Access Compliance Report

Public Rights-of-Way

(Curb Ramps)

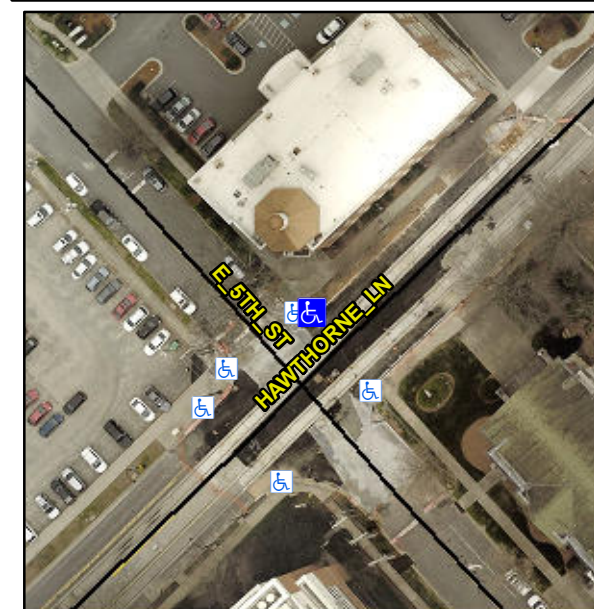
Intersection ID: 13871	Main Street: E_5TH_ST	Cross Street: HAWTHORNE_LN	Location: NE
ADA ID: E5CACB6E0173	Ramp Type: Directional1	Initial Pass/Fail: Fail	Overall Compliance: No
Severity Score: 12.5			
Codes/Mitigation Info/Possible Solution		Field Measurements/Component Compliance

R304.2.2

Remove & Replace Entire Ramp.
